# 6. Intake and Exhaust System

#### General

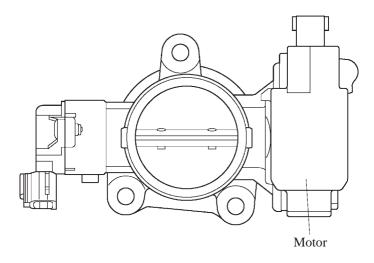
- The motor of the diesel throttle valve has been changed from a step motor type to a rotary solenoid type in order to attain quick reponse and to suppress smoke emissions.

A rotary solenoid type motor has been adopted in the diesel throttle valve. This makes the throttle valve respond quickly.
